Ref.: PW/NGP/PUR/1906070/Corrigendum-04

Sub: Corrigendum-04 for issuance of separate Sketch and detailed Drawing for better understanding of dimension of container.

Job: Design, manufacture and supply of 01 No. Prefabricated container at 2 X 800 MW NTPC Ramagundam Site on F.O.R. destination basis

Ref:- Tender Enquiry Number: 1906070

PRE-FAB CONTAINER SKETCH

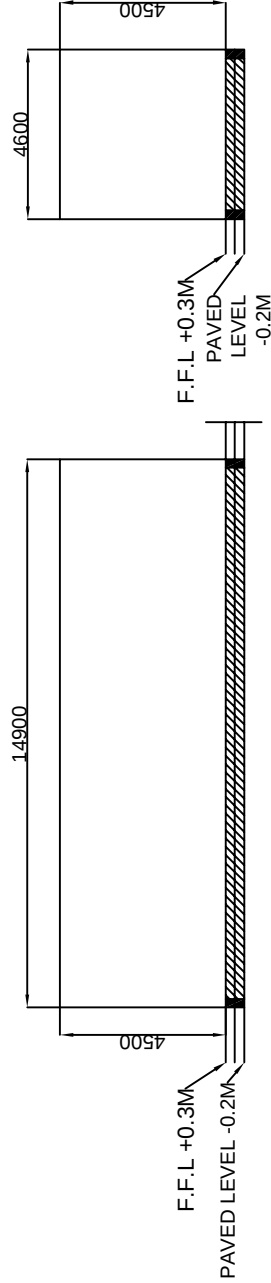
Note: Separate sketch of container along with detailed drawing (9591-102-102-PVE-Y-029) is being issued herewith. Separate sketch is provided only for better understanding of dimension of container for bidder. However detailed engineering and fabrication including doors, windows, toilet and other accessories etc. is to be done as per drawing number 9591-102-102-PVE-Y-029. Based on this input drawing (9591-102-102-PVE-Y-029), detailed engineering including GA drawing needs to be submitted by bidder to BHEL/NTPC for approval as per TCC.

TITLE												
ELECTRICAL EQUIPMENT & CABLING LAYOUT IN AUX. BOILER MCC ROOM												
								DEPT.	SCALE 1:100	DRAWING NO.		
								SIGN		PE-DG-424-100-E019		
										SHEET 1	OF 1	REV. 05

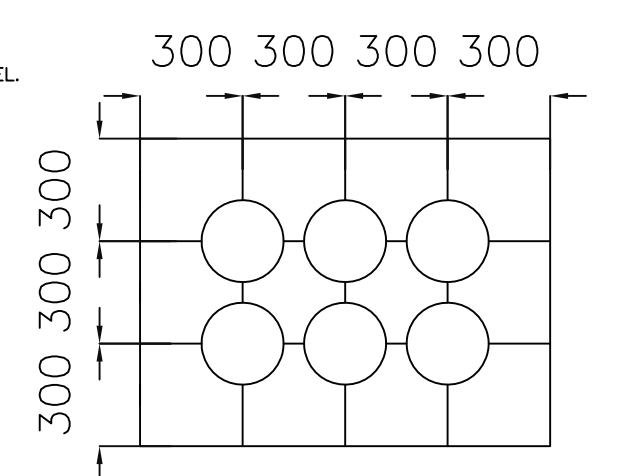
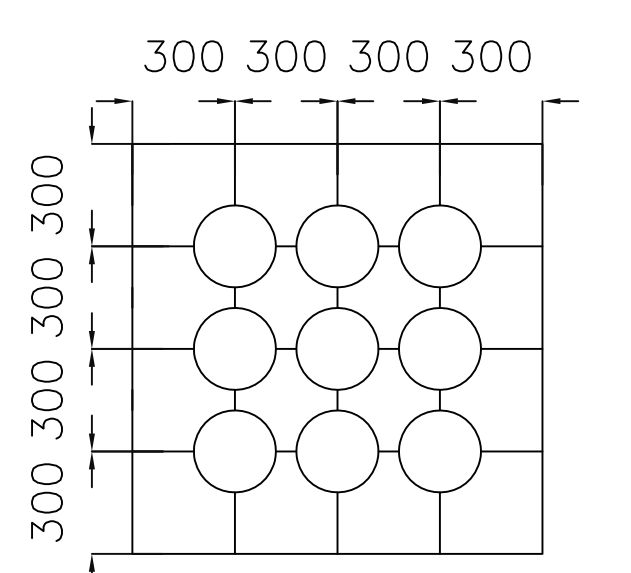
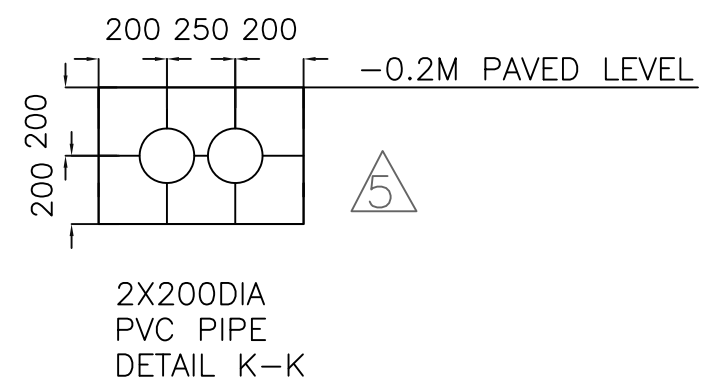
DTD. 26.07.2019		
2X800MW TELANGANA PROJECT (KARIMNAGAR)		
	NTPC DRG NO.- 9591-102-102-PVE-Y-029 R4 (Electrical Equipment & Cabling Layout in AUXILIARY BOILER AREA)	
	NTPC COMMENTS DTD.11.07.19 REF NO. 102/25601 on REV 04	
	<u>NTPC COMMENT</u>	<u>BHEL REPLY</u>
1	INDicate depth of Pull pit and please ensure thattop of pull pit shall be sand filled and covered with PCC after completion of cabling job.	Depth of Pull Pit is 1200MM & we ensuer that top of pull pit shall be sand filled and covered with PCC after completion of cabling job.
2	Please submit the contained GA drawing before submission of this drawing	This drawing is input for vendor to develop GA drawing of container. Therefore customer is requested to approve the document so that subsequently container drawing may be submitted.
4	As commented previously for better aesthetic and movement of people please provide PVD pies in RCC	Revised in Layout Drwaing (refer Section K-K).
